**SUBJECT:** BCC Agenda Item – Consent Agenda  
February 20, 2018 BCC Meeting  
Change Order Number 001 to Contract Y17-774, Cell 9-10 Leachate  
Pump Station No. 1  
Contact Person: James Becker, Manager  
Utilities Solid Waste Division  
407-254-9660

Contractor: **Eclipse Construction Company** Change Order #: **001**  
Date:  
Contract No.: **Y17-774** Original Contract Amount: **\$598,000.00**  
Contract Name: **Cell 9-10 Leachate Pump Station No. 1** Revised Contract Amount: **\$700,490.64**  
Engineer: **Neel-Schaffer, Inc.**

Orange County Solid Waste Cell 9-10 Leachate Pump Station #1

REQUEST FOR PROPOSAL (RFP) FOR PROPOSED CHANGE NO. 001

Description of Item Attached	No. of Copies
1.	<b>Site Condensate Line Improvements</b>	<b>PDF</b>
2.		
3.		
4.		
5.

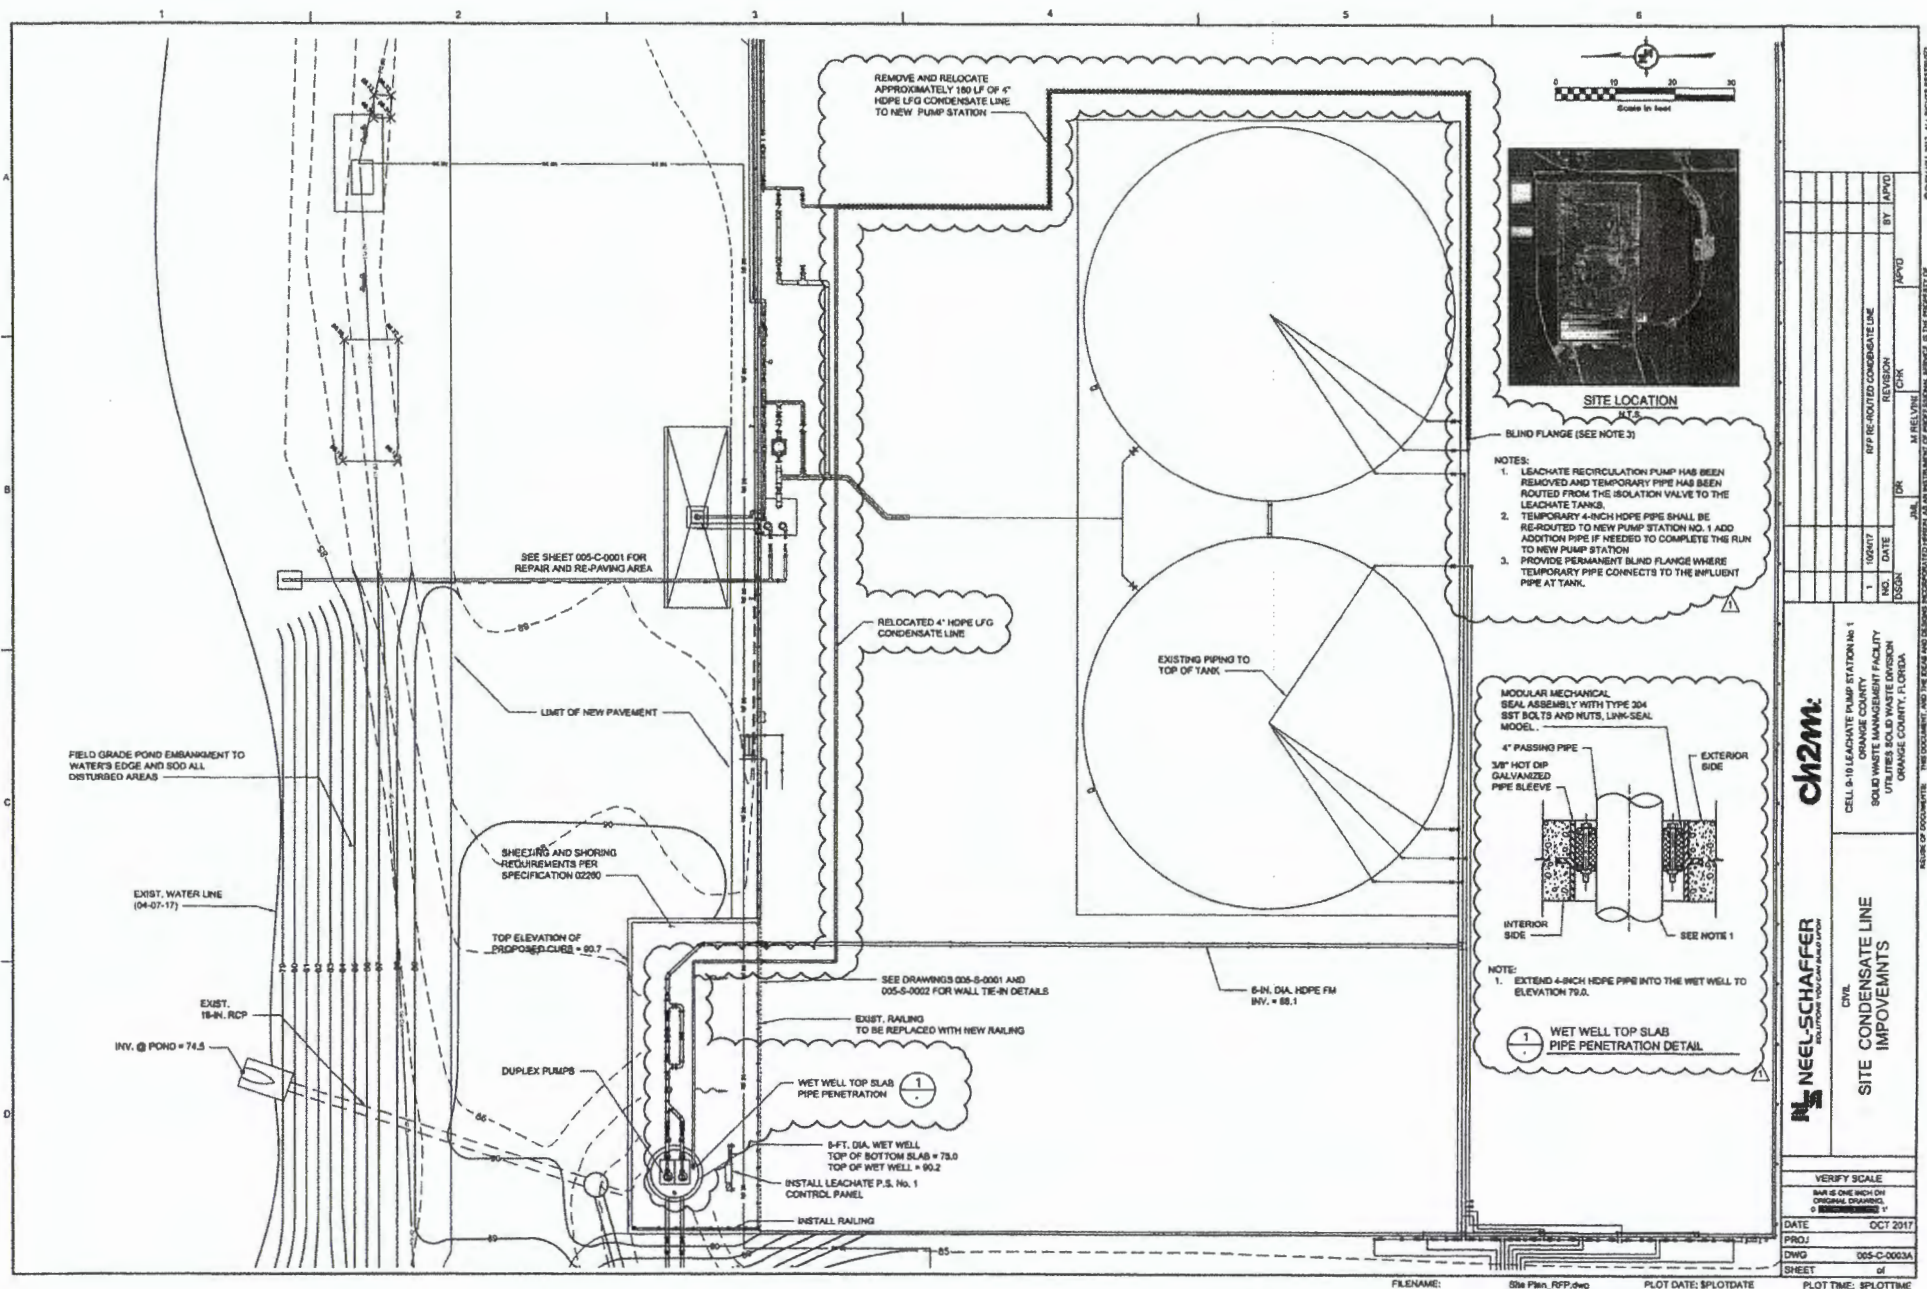
Re-route an existing landfill gas condensate pipe as indicated on the attached drawings. The existing 4-inch diameter HDPE pipe is to be removed and relocated as indicated on the plans and connected to the proposed pump station wetwell. The work includes installation of a 4-inch plug valve, blind flange and all required fittings. The installation of the HDPE pipe by the Contractor shall be in accordance with the specifications.

**ONE-LINE DIAGRAM**

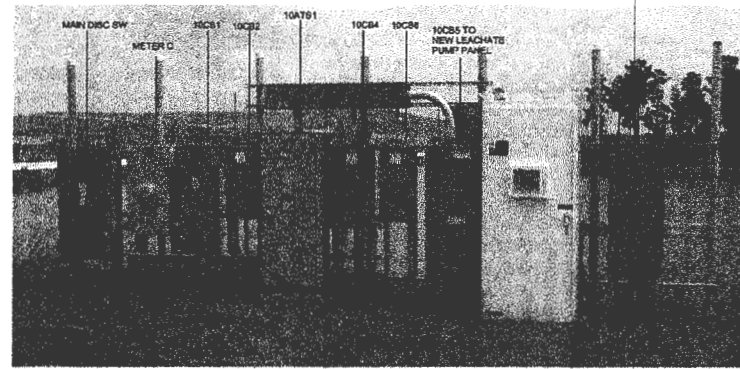
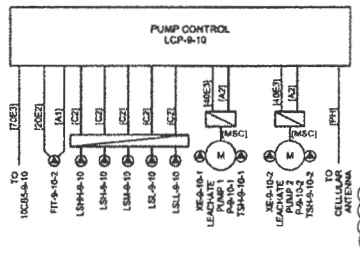
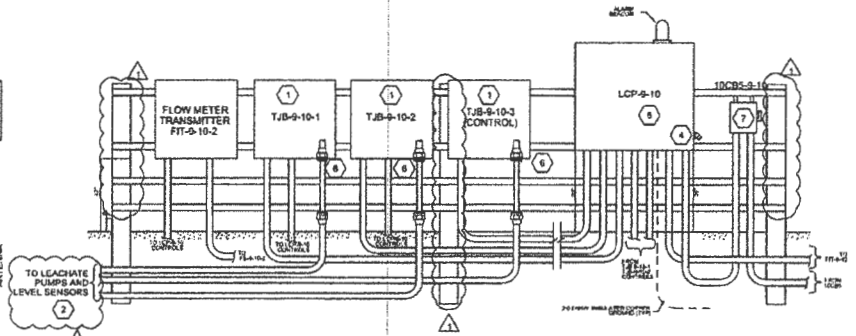
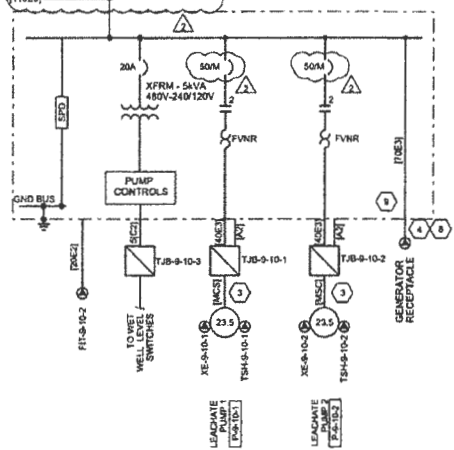
In our response to CCIR-1 we stated: XYLEM/Flygt's Model D8058/444, 20 HP pump specified is no longer rated for Class I, Division 1, Group D service; therefore, the pump specified in the bid documents cannot be used for this project.

We proposed the 23.5 HP Model FA 10.65E pump by Wilo EMU as a substitute for the specified pump. This pump has an explosion-proof motor rated for Class I, Division 1, Group D service, and has corrosion-resistant components.

The proposed pump data, pump curve, dimensional drawings and manufacturer data were attached to our response to CCIR-1. The Supplemental Data Sheet from Specification Section 11305 was revised and submitted to you to reflect the new pump selection and is attached. The rail system shall be as provided by Wilo EMU. In addition, please provide the vendor the lift cable and guiderail length included in the data sheet. The revised electrical plans to accommodate the new pump was also included in our response to CCIR-1. Revised electrical requirements for the larger horsepower pump were included in Revised Drawing 005-E-5001.

The electrical plans have been revised to accommodate the new pump. Revised electrical requirements for the larger horsepower pump are included in Revised Drawing 005-E-5001, attached.

FA 10.65E

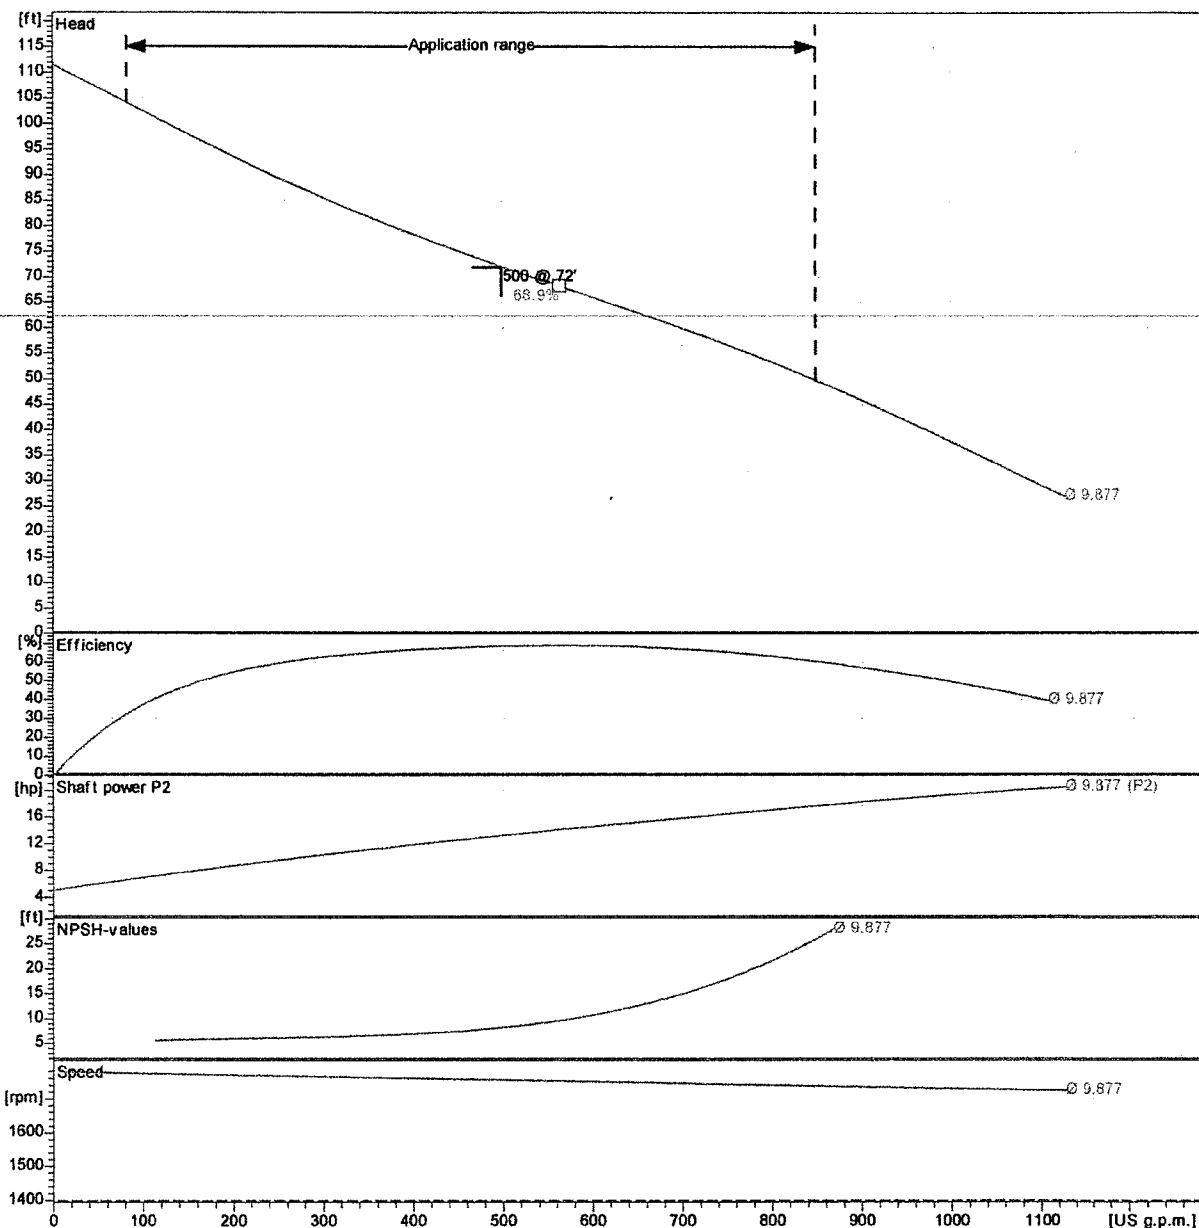
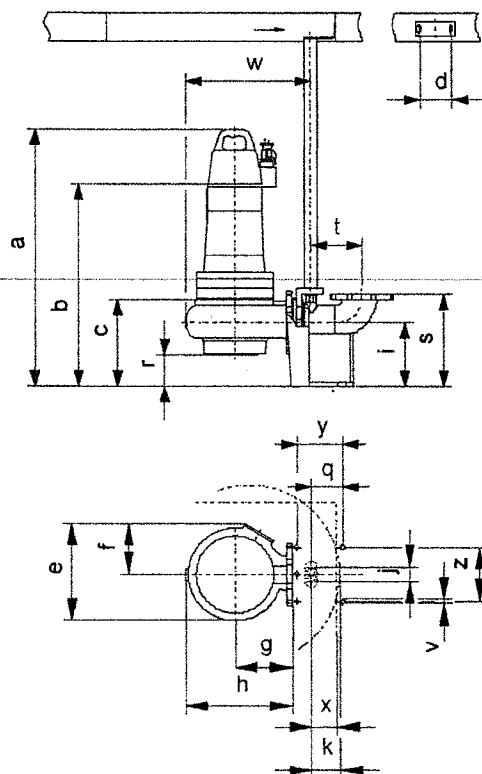
We propose the 23.5 HP Model FA 10.65E pump by Wilo EMU as a substitute for the specified pump. This pump has an explosion-proof motor rated for Class I, Division 1, Group D service, and has corrosion-resistant components.

The proposed pump data, pump curve, dimensional drawings and manufacturer data are attached. The Supplemental Data Sheet from Specification Section 11305 has been revised to reflect the new pump selection and is attached. The rail system shall be as provided by Wilo EMU. Contractor shall provide the vendor with lift cable and guiderail length.
